Access Compliance Report

Public Rights-of-Way

(Curb Ramps)

Intersection ID: 28310	Main Street: ARDREY_KELL_RD	Cross Street: WADE_ARDREY_RD	Location: SE
ADA ID: C969A8FC247A	Ramp Type: Perp	Initial Pass/Fail: Fail	Overall Compliance: No
Severity Score: 12.5			
Codes/Mitigation Info/Possible Solution		Field Measurements/Component Compliance

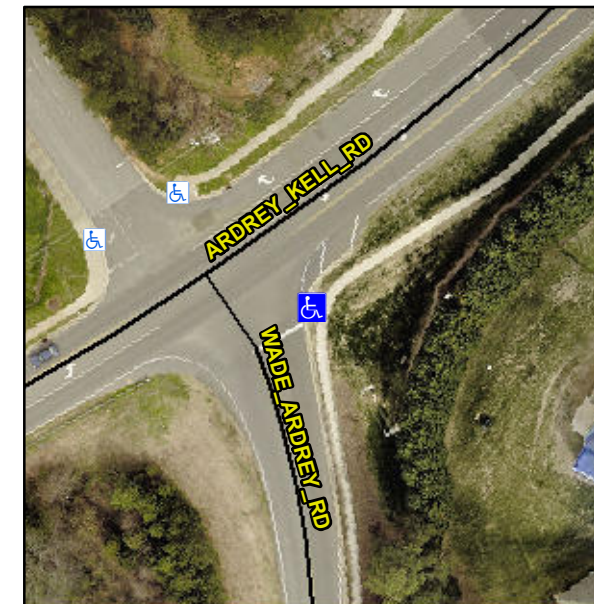
Not Found, R304.2.2

Compliance	Description	Data	Compliance	Description	Data
N/A	Ramp Length (in)	72.0	No	Ramp Slope (%)	9.9
Yes	Ramp Width (in)	48.0	Yes	Ramp XSlope (%)	1.2
N/A	Flare Type LT	N/A	N/A	Flare Type RT	N/A
N/A	Flare Slope LT (%)	N/A	N/A	Flare Slope RT (%)	N/A
N/A	Flare Traversable LT?	N/A	N/A	Flare Traversable RT?	N/A
N/A	Landing Length (in)	N/A	N/A	DWS Provided?	N/A
N/A	Landing Width (in)	N/A	N/A	DWS Contrast?	N/A
N/A	Landing Slope (%)	N/A	N/A	DWS Length (in)	N/A
N/A	Landing X Slope (%)	N/A	N/A	DWS Full Width?	N/A
N/A	Landing Curb? (Y/N)	N/A	N/A	DWS Offset (in)	N/A
N/A	Shared Landing?	N/A			
N/A	Gutter Ponding?	N/A	N/A	Gutter Slope (%)	N/A
N/A	Gutter Lip Ht (in)	N/A	N/A	Gutter X Slope (%)	N/A
N/A	Painted X Walk1?	No	N/A	Painted X Walk2?	N/A
	X Walk 1 Direction	To NW		X Walk 2 Direction	N/A
N/A	X Walk 1 Width (in)	N/A	N/A	X Walk 2 Width (in)	N/A
	X Walk 1 Slope (%)	0.3		X Walk 2 Slope (%)	N/A
	X Walk 1 X Slope (%)	0.9		X Walk 2 X Slope (%)	N/A

Remove & Replace Entire Ramp.
